Appl. No. 10/517,143  
Amendment dated August 23, 2006  
Reply to Office Action of May 30, 2006

**AMENDMENTS TO THE DRAWINGS:**

## *Fig. 3* Exhibit A

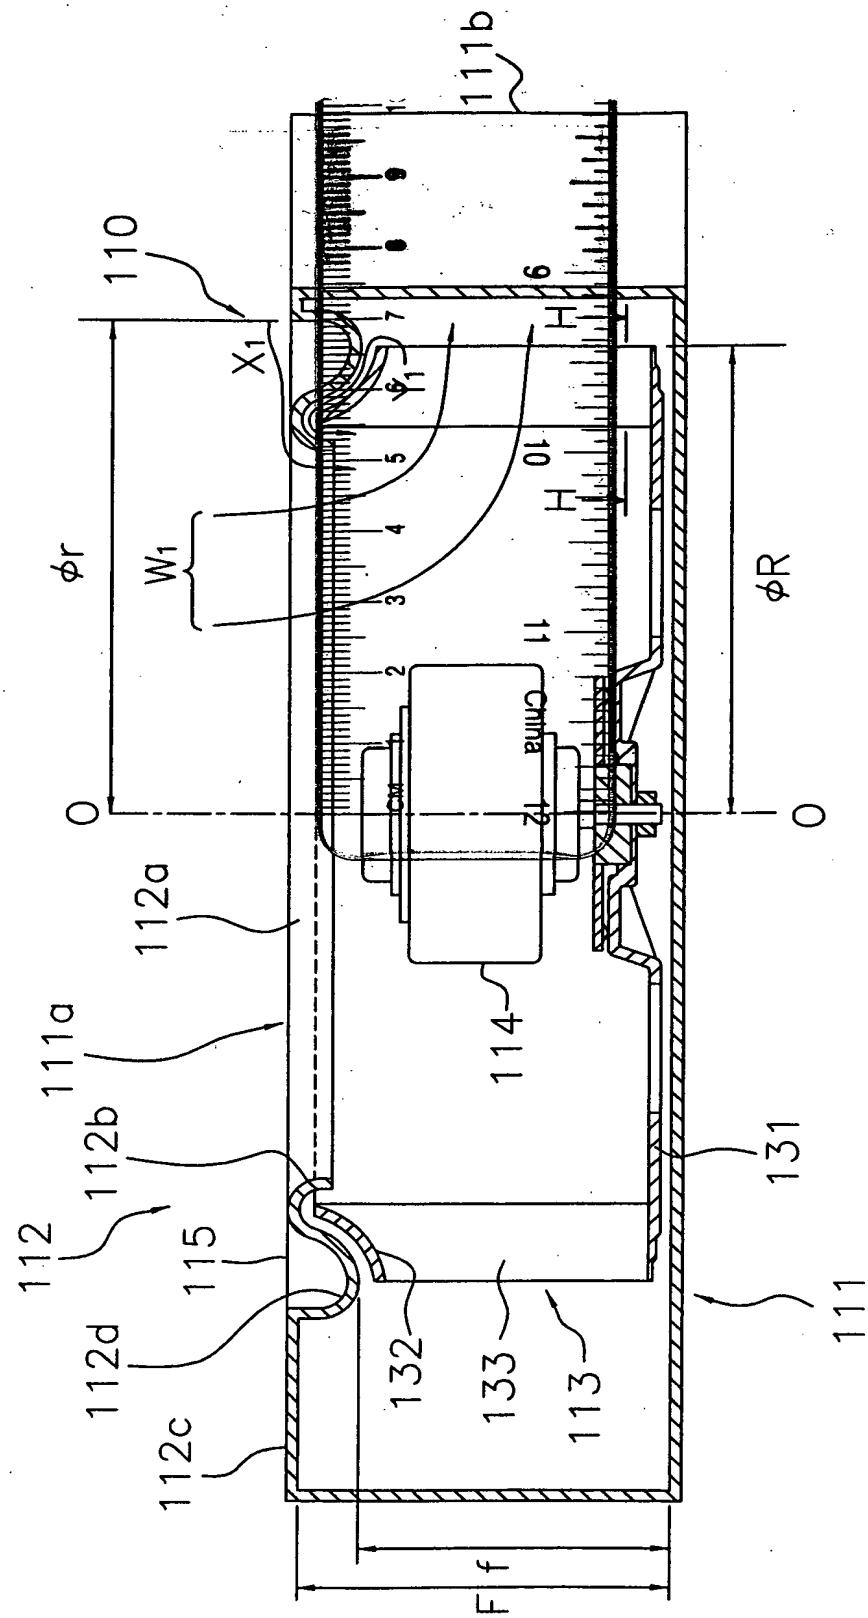
The attached sheet of drawings includes a change to Figure 3. Specifically, the dimensions of the first length ( $\varphi r$ ) and the outer radius ( $\varphi R$ ) are shown. This sheet, which includes Figure 3, replaces the original sheet including Figure 3.

On page 2 of the Office Action, the drawings were objected to as failing to comply with 37 CFR §1.83(a).

The dimensions of the first length ( $\phi r$ ) and the outer radius ( $\phi R$ ) and the connecting portion (D) are illustrated in Figure 5, which is an enlarged view of Figure 3. Applicant submits herewith an amended Figure 3 that shows the dimensions of the first length ( $\phi r$ ) from the rotational axis (O-O) to the connecting portion (D) and the outer radius ( $\phi R$ ) of the impeller 113.

Referring to Exhibit A in Applicant's Remarks, a ruler is superimposed on amended Figure 3. As can be seen from Exhibit A, the first length ( $\phi r$ ) is illustrated with a length of about 7 cm and the outer radius ( $\phi R$ ) is illustrated with a length of about 6.6 cm. Thus, the ratio  $(\phi r) / (\phi R) \approx 7 / 6.6 \approx 1.09$  is illustrated in Figure 3. Accordingly, a ratio between the claimed range of greater than or equal to 0.8 to less than 1.4 is shown in Figure 3. The objection in the Office Action referred to a ratio less than 1. It is unclear why a ratio less than 1 is needed to be shown. Applicant respectfully submits that the drawings comply with

37 CFR 1.83(a) since a ratio within the claimed range is illustrated. Applicant respectfully requests withdrawal of the objections.
